February 4, 2019

RE: *Response to a Letter from the Town of Bancroft Regarding The Traffic Impact Study prepared for Freymond Aggregates Quarry*

Exhibit 6 2025 Total Peak Hr Volumes

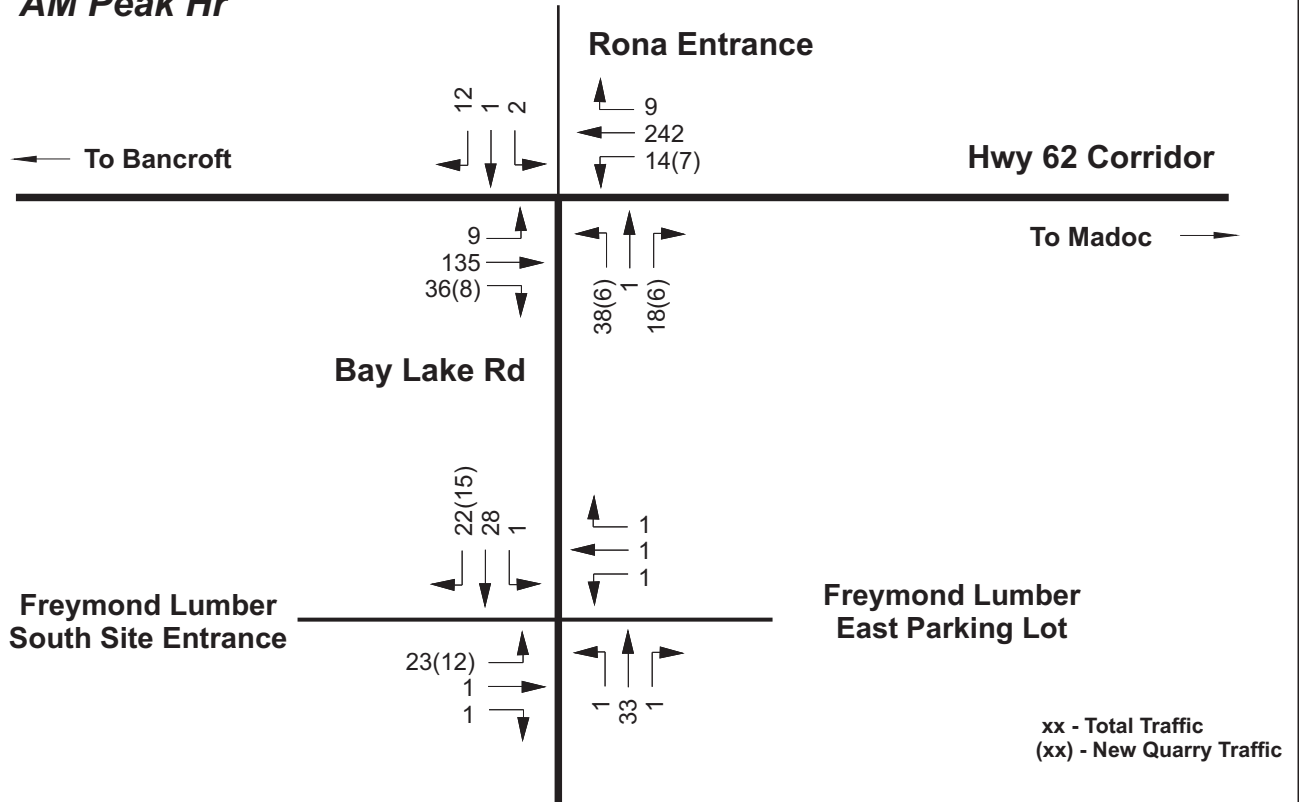
2. *The Traffic Impact on the Mill Street/Bridge Street Intersection*

Response: The December, 2016 clearly identifies forecast future site traffic since that is one of the key roles of the traffic study. Reference to the forecast site traffic volumes can be found in:

- The quarry haul routes will generally be over road platforms designed to carry truck traffic as in the case of Kings Highways and County roads.
- The forecast *Freymond Quarry* site traffic is clearly illustrated in *Exhibit 6 of the December, 2016 Traffic Study Report*. A copy of this exhibit is attached following. In reviewing this exhibit it will be noted that the forecast peak hour quarry total site traffic travelling to/from Bancroft is 8 vehicles per hour (vph) northbound and 6 vph southbound during a representative 2025 PM peak hour. However, only half this traffic will be trucks (see *Table 2, 2016 Report*) Since trucks are only one component of this total site traffic volume, it is likely that their overall impact on road infrastructure will not be significant.

Response: Referring to the attached volume exhibit from the December, 2016 report, it can be seen that total quarry site traffic will be around 6 to 8 vehicles per hour in each direction. When applying the current Highway Capacity Manual (HCM) equations to assess the capacity of intersection operations, this low volume of site traffic will have little impact on present and future Levels of Service at this intersection. The future operation of the intersection will be determined by the future levels of background traffic.

In reviewing *Table 2* it should be noted that the future truck traffic component is about 50% of the total forecast site traffic. This means that truck traffic volumes on roads approaching/departing the Town of Bancroft will average during peak hour conditions approximate 3 to 4 trucks per hour in each direction. This amounts to one truck every 15 to 20 minutes in each direction.
